SCHEMATIC SC-X3 FEBRUARY 1979

# Acoustal Monitor-X OTL

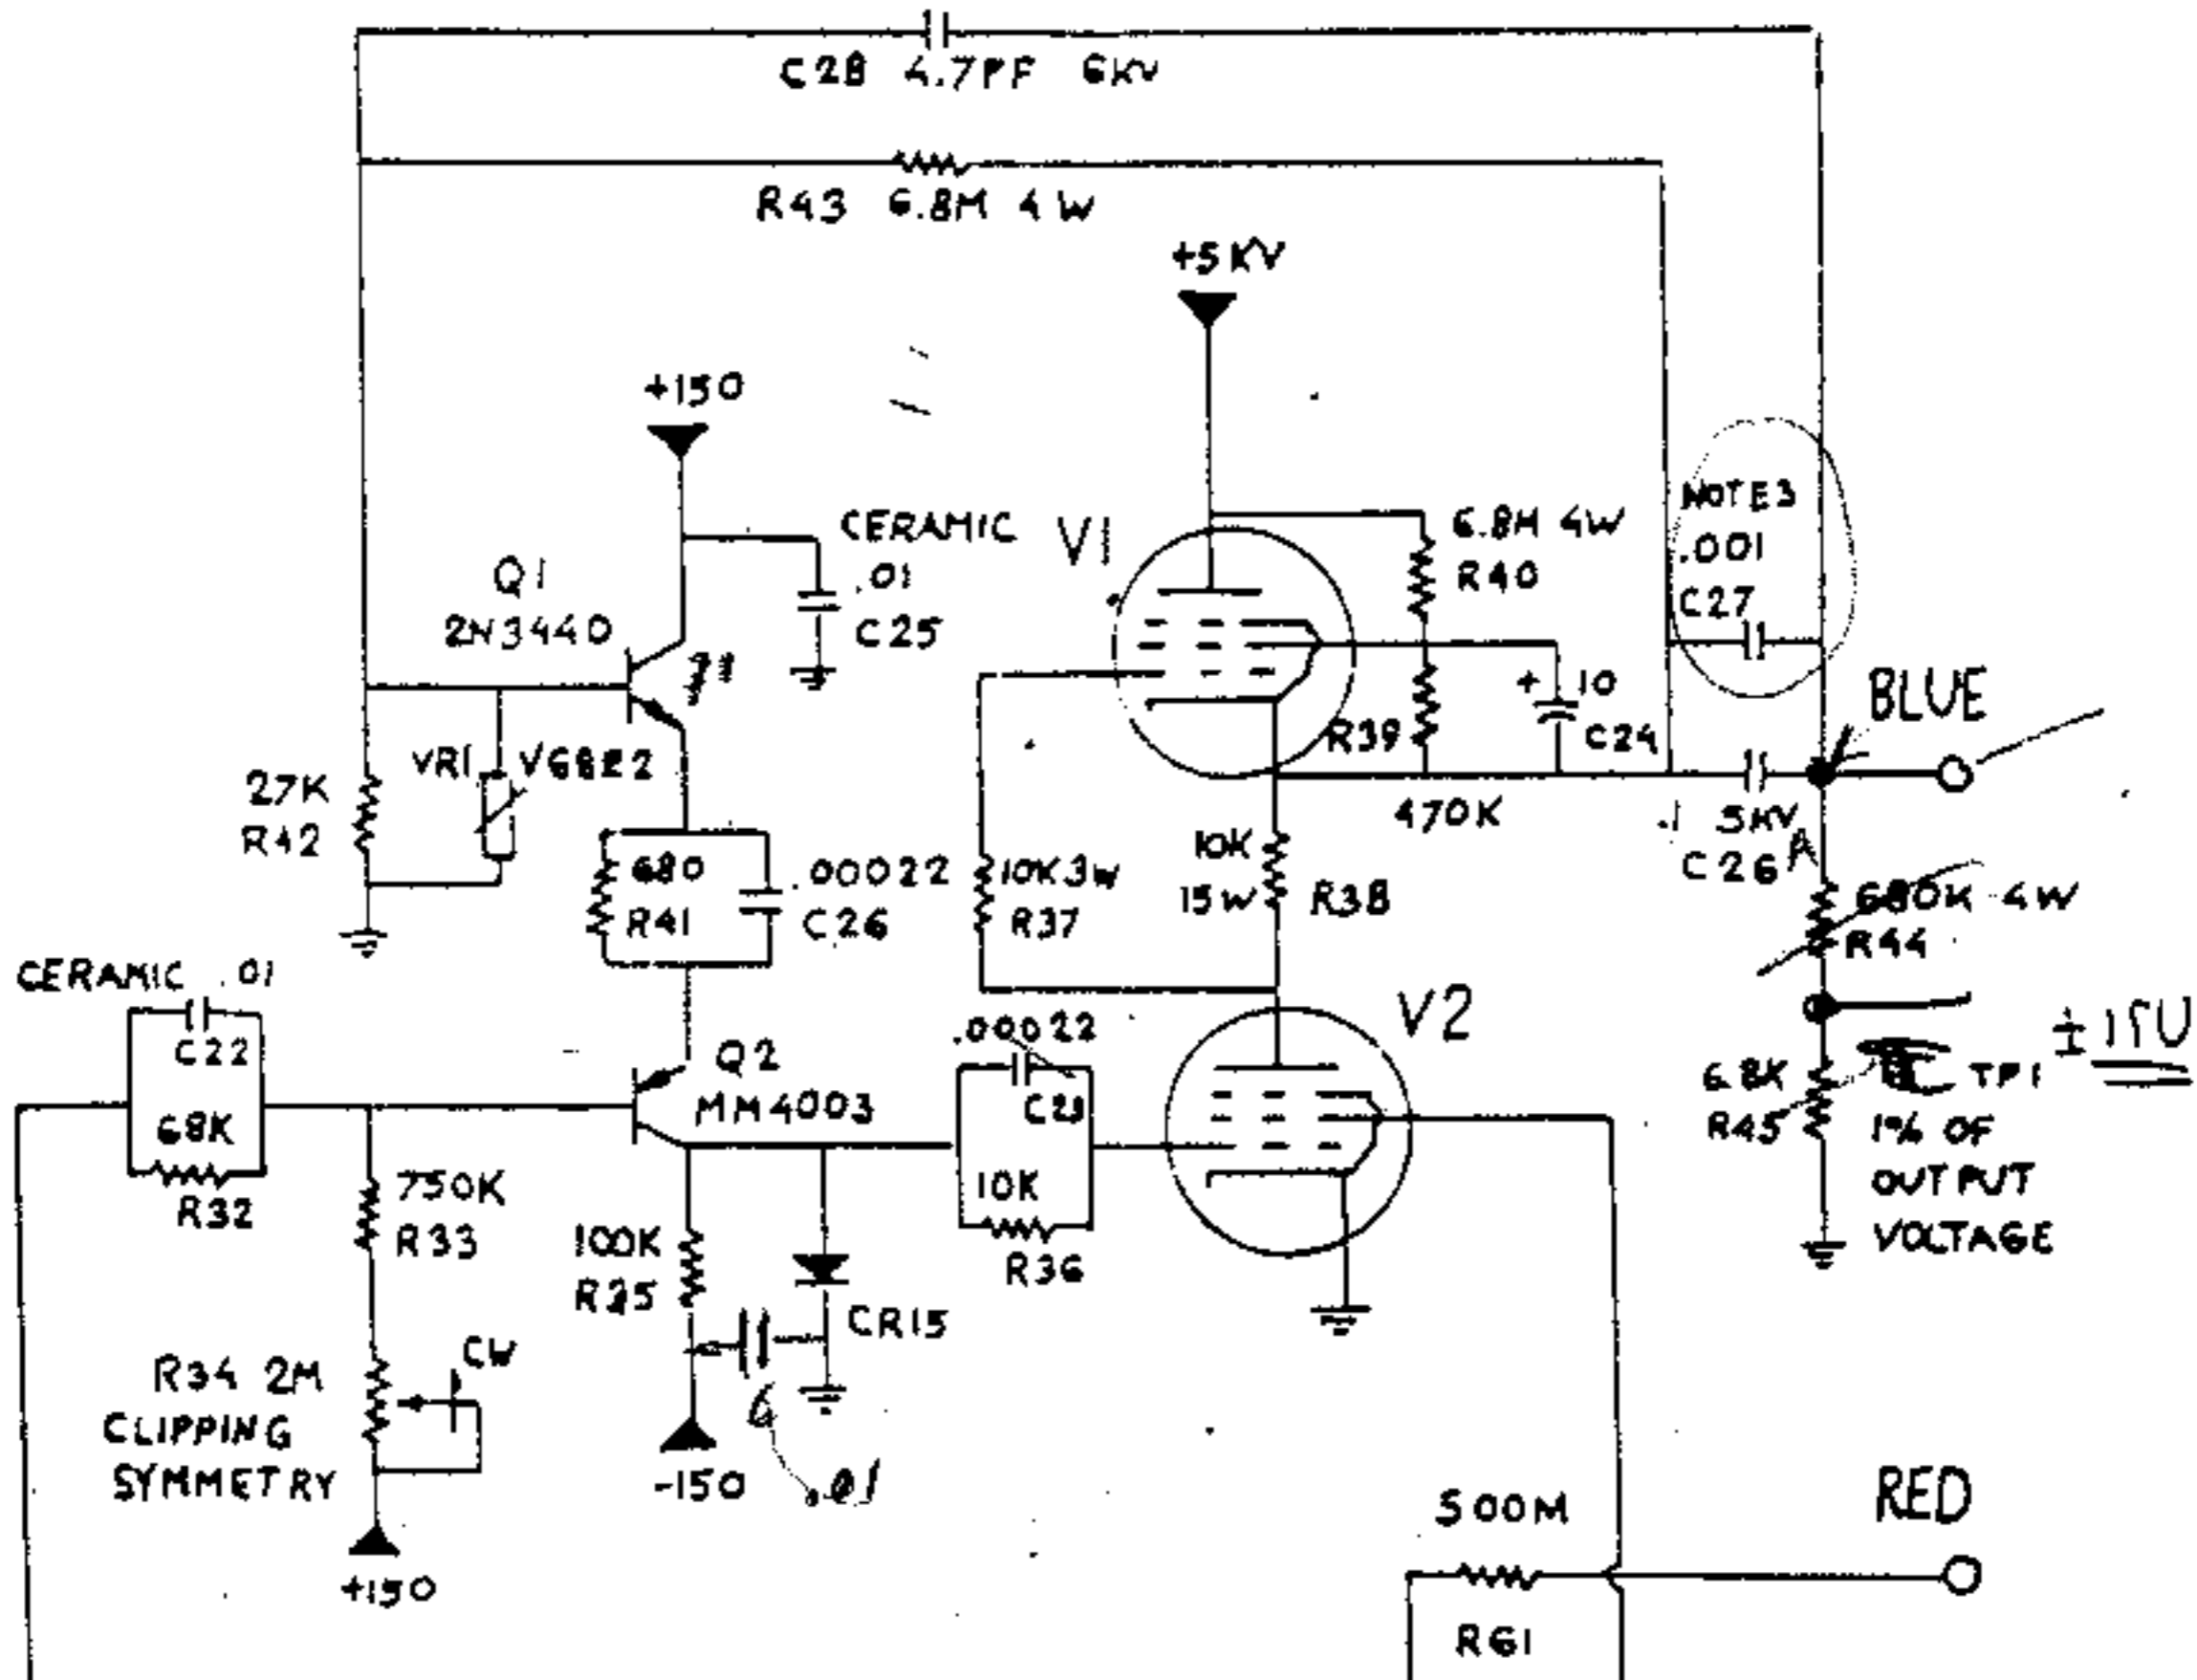
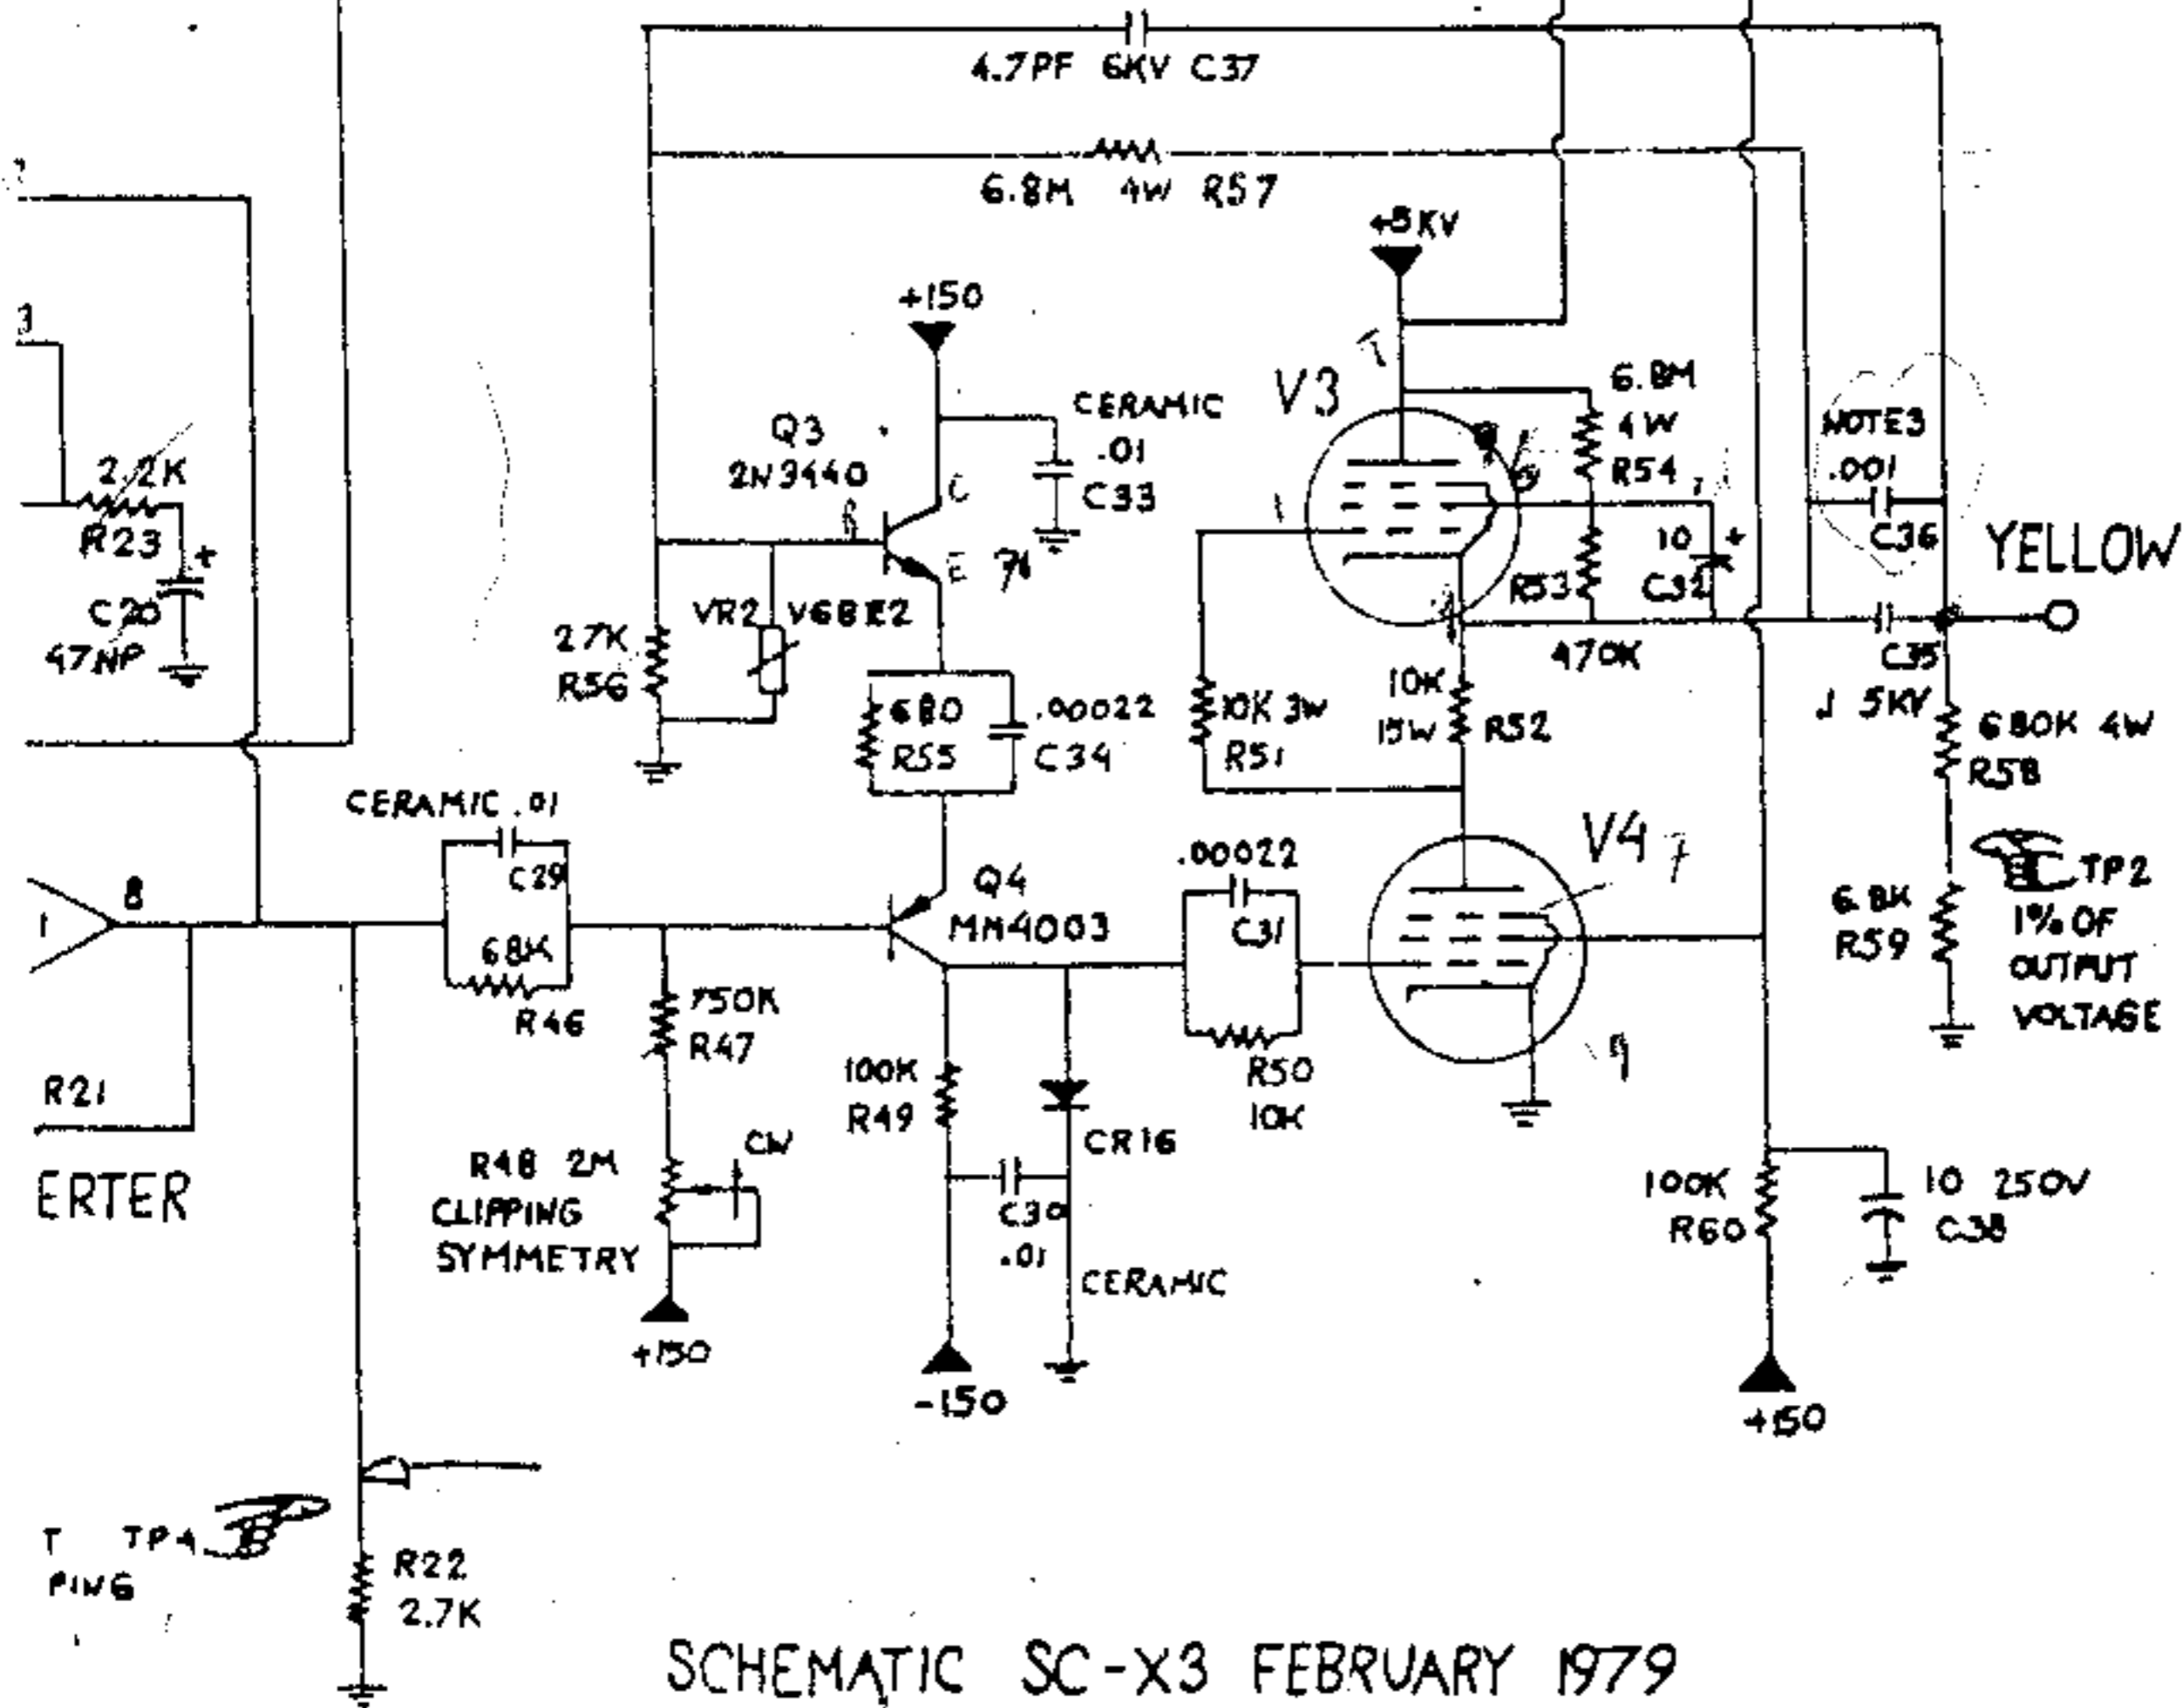
RECEIVER INPUT DELETED  
 AND R25 ADDED FROM  
 CHASSIS 1700 OH

C15, C15A, C20, C27, C36, R15, & R18  
 INVOLVE CHANGES IN PRODUCTION.  
 THE EARLIER VALUES ARE:  
 C15 15μF OR 33μF TANTALUM  
 C20 15μF TANTALUM  
 R15 6.8KΩ  
 R18 68KΩ  
 C15A, C27, C36 OMITTED

KIT AVAILABLE TO CONFORM TO  
 SCHEMATIC VALUES

1N4004 ACCEPTABLE FOR  
 CR5-CR8 & CR13-CR16
